Full Planning Applications: Flood Risk and Drainage Checklist

SITE: Land adjacent to Jessamine Cottage off Main Street, Llangrove, Ross on Wye, Herefordshire, HR9 6ET
DESCRIPTION: Proposed erection of 18 new homes with new access off Main Street, Llangrove
APPLICATION NO: 172905
GRID REFERENCE: OS 352902, 219124
APPLICANT: Mr Tom Aylmer
AGENT: Mr Geoffrey Prince
DATE OF THIS RESPONSE: 1/12/2017

Figure 1: Environment Agency Flood Map for Planning (Rivers and Sea), May 2017

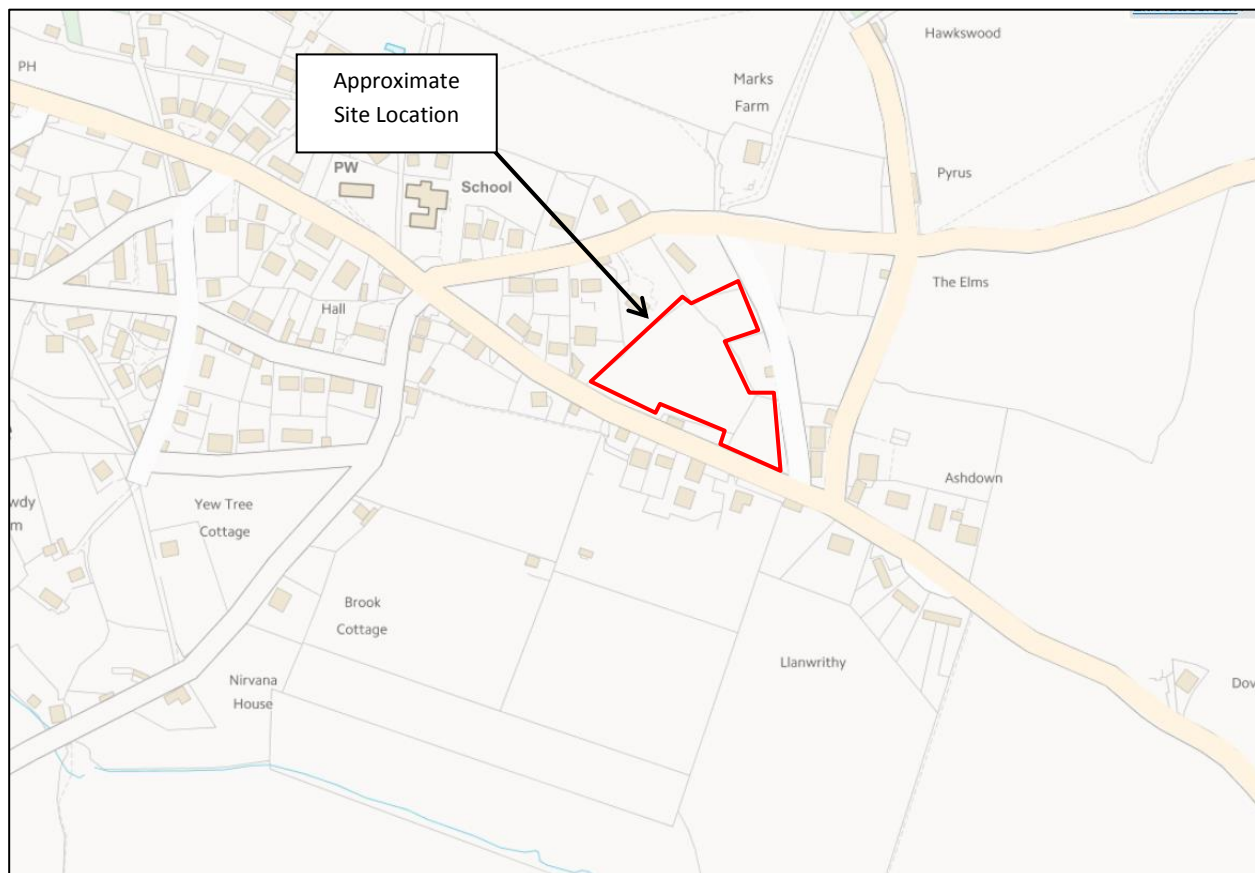
Information required	Reviewer comments	✓ ✗
Sources of risk		
Assessment of Flood Zone 2 and 3 taking the effects of climate change into account, including predicted flood depths for the 1 in 100 and 1 in 1000 annual probability events	Review of the EA's Flood Map for Planning and submitted FRA confirms the location of the site in Flood Zone 1.	✓
Assessment of areas protected by flood defences and risk of flooding in the event of breach, taking the effects of climate change into account	The site is located in Flood Zone 1 and therefore not at risk of flooding in the event of defence breach.	✓
Assessment of fluvial flood risk from other watercourses in close proximity (c.20m) to the site including those with no mapped flood extent, and taking the effects of climate change into account	Review of OS mapping indicates that there are no ordinary watercourses in close proximity to the proposed development.	✓
